Our Ref: 80216045-CV1B-RP-001:AL  
Contact: Robert Lewis

## **MARRICKVILLE METRO S75W PROPOSED MODIFICATION RESPONSE TO SUBMISSIONS**

meters

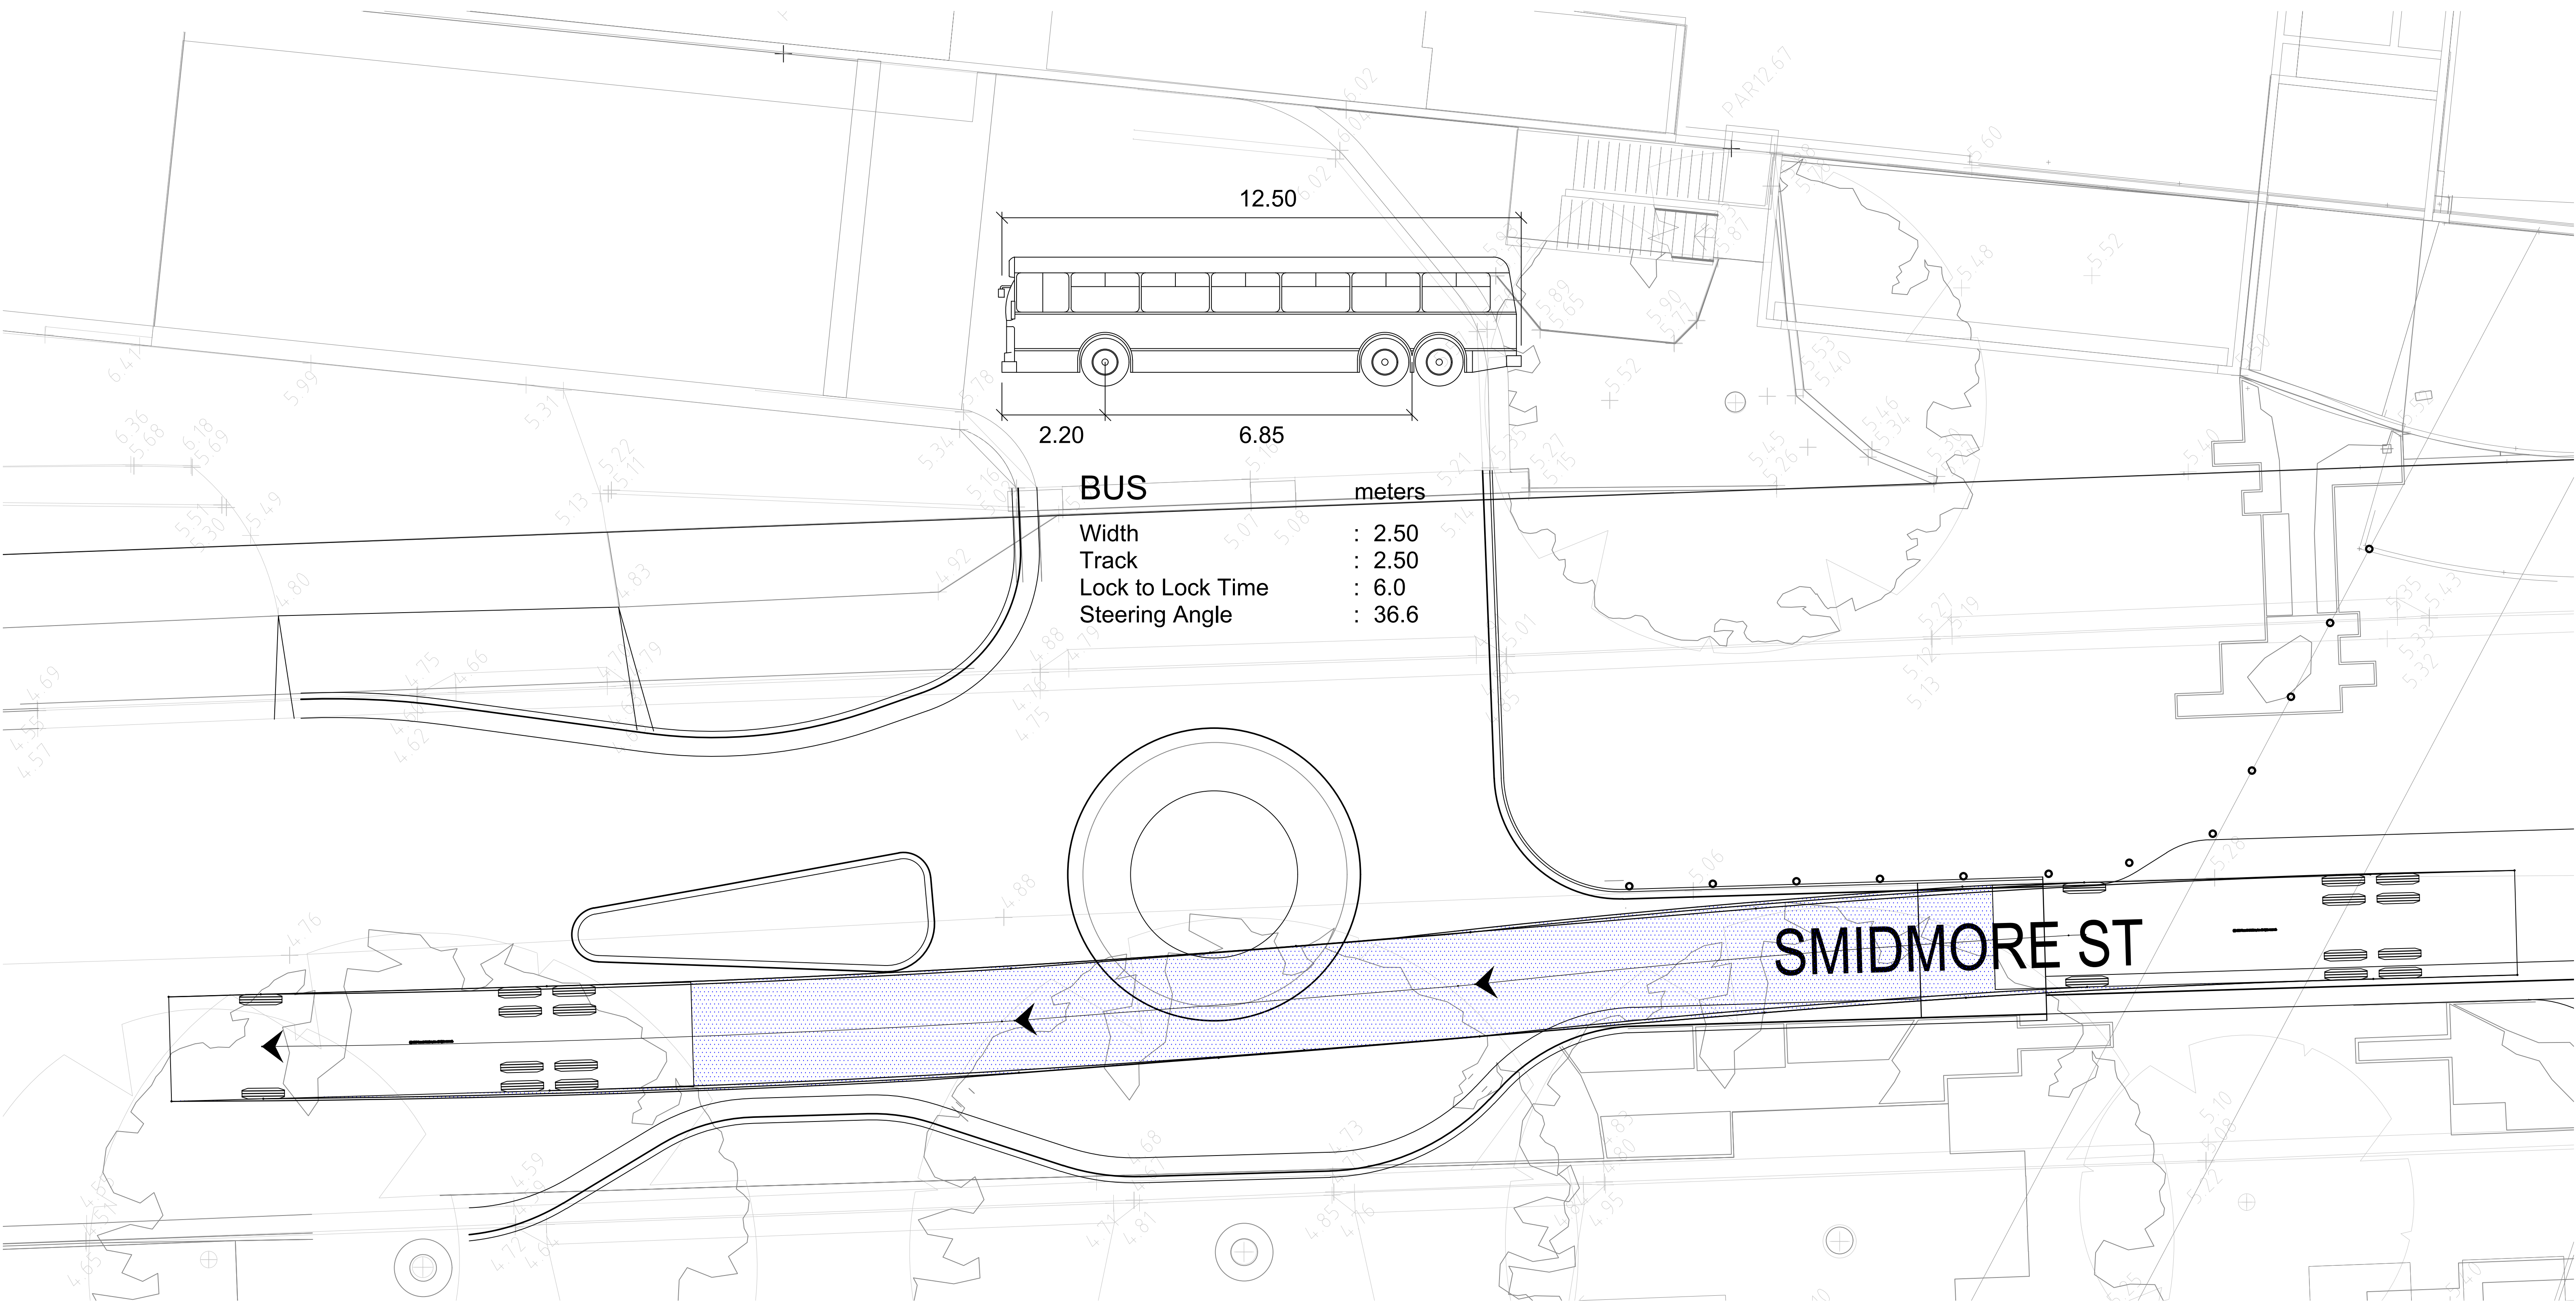
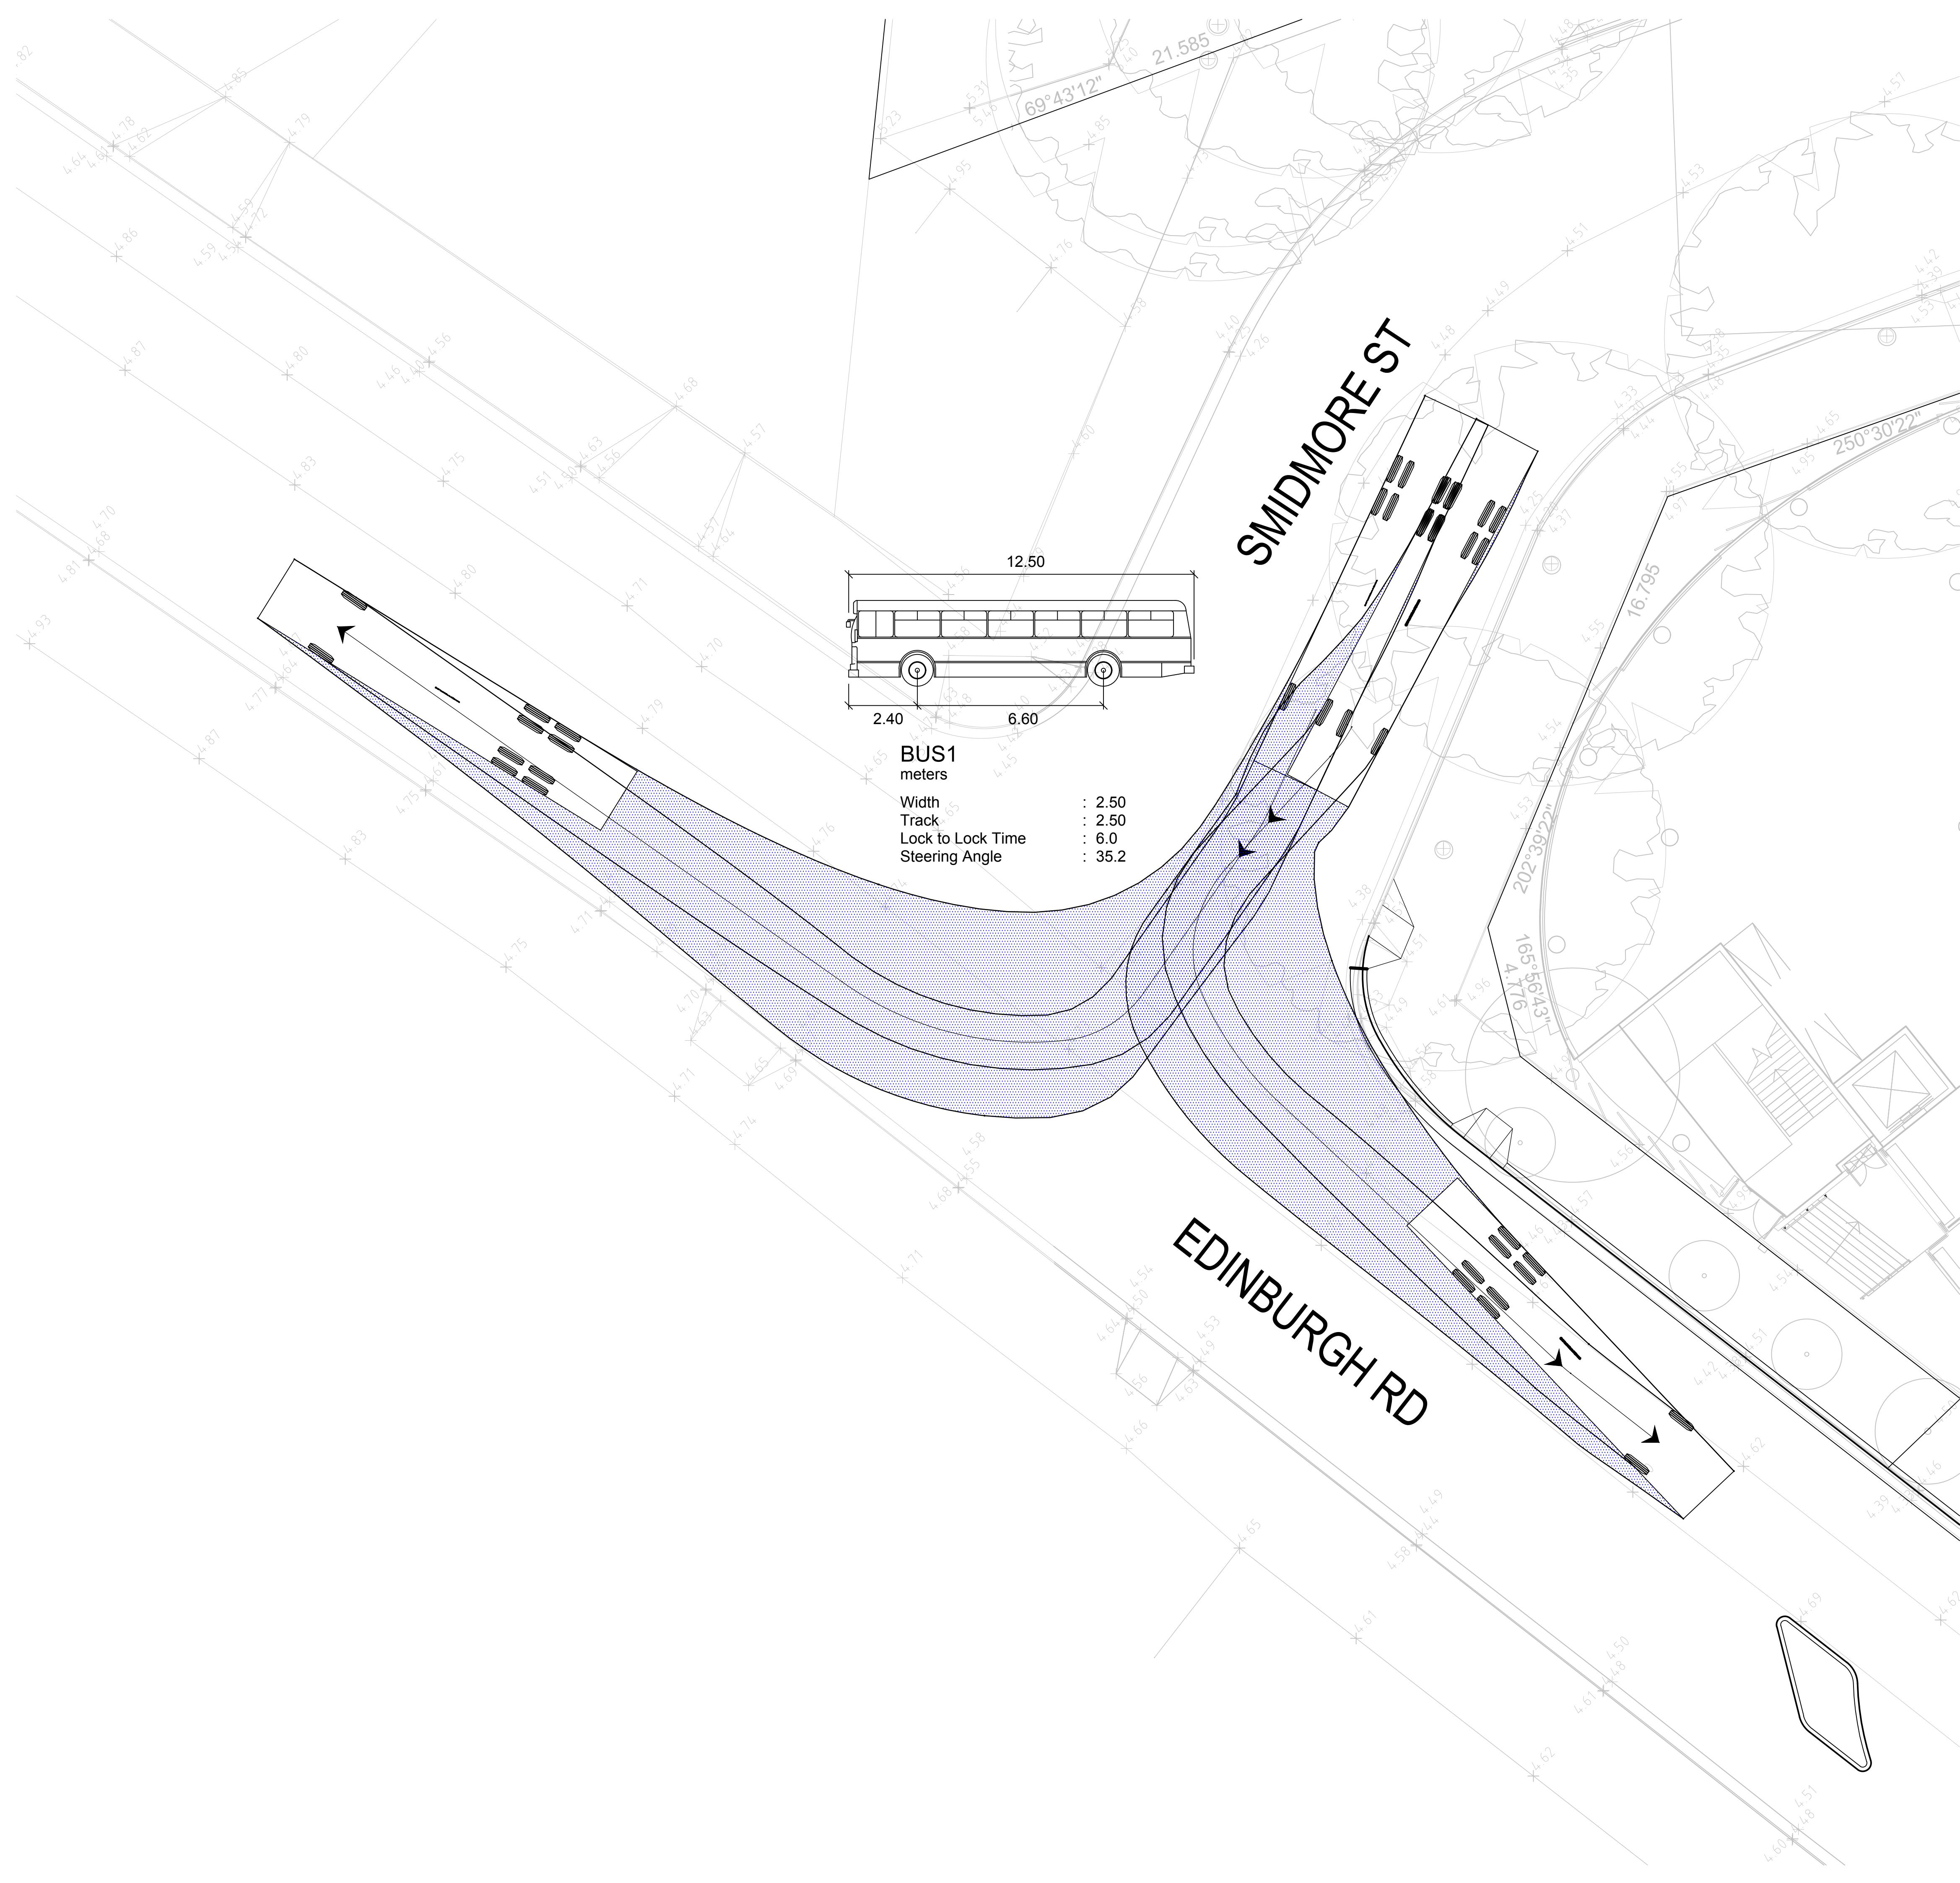
*'3. Provide additional information to demonstrate that the movement and interaction of vehicles and pedestrians in Smidmore Street can occur safely, having regard to the operation of the existing loading dock, the entry/exit ramp to the existing carpark and the roundabouts.'*

*'Swept path analysis should be prepared to demonstrate the proposed road configuration on Smidmore Street is adequate to accommodate the manoeuvring of the proposed community bus service.'*

*'The applicant should provide further information on how the existing loading dock will be operated and accessed from Smidmore Street. Swept path analysis should be prepared to demonstrate the adequacy for truck access having regards to the proposed roundabout and one-way access off Murray Street'*

*'3. Swept paths should be provided for Smidmore Street, with larger vehicles being able to manoeuvre around the roundabout without having to undertake a 3-point turn.'*

Cardno have completed turnpath analyses for various vehicles. The turnpaths demonstrate safe traffic flow around the existing entry/exit ramp and proposed roundabout by showing 99<sup>th</sup> percentile car entry, exit and U-turn movements. Refer to **Appendix A** for turnpath sketches.

The turnpaths also demonstrate that vehicles under 7m total length accessing the existing loading dock without encroaching other vehicle and pedestrian pathways. Vehicles exceeding 7m will require local pedestrian traffic control and retracting of the proposed removable bollards to access the existing Smidmore street loading dock. Refer to **Appendix A** for turnpath sketches.

Cardno have completed turnpath analyses for community bus service movements. The turnpaths demonstrate safe and adequate movement throughout proposed Smidmore Street arrangement inbound, through fare and outbound movements. Turnpath analysis also shows U-turn movements for community buses at the proposed Smidmore Street roundabout. Refer to **Appendix A** for turnpath sketches.

The turnpaths analysis demonstrates safe large vehicles movements around the proposed roundabout by showing the community bus accomplishing U-turns. Refer to **Appendix A** for turnpath sketches.

DELIVERY VEHICLE TO LOADING DOCK BAYS PERMITTED  
ONLY WHEN REMOVABLE BOLLARDS ARE RETRACTED  
AND PEDESTRIAN TRAFFIC CONTROL IS PRESENT.
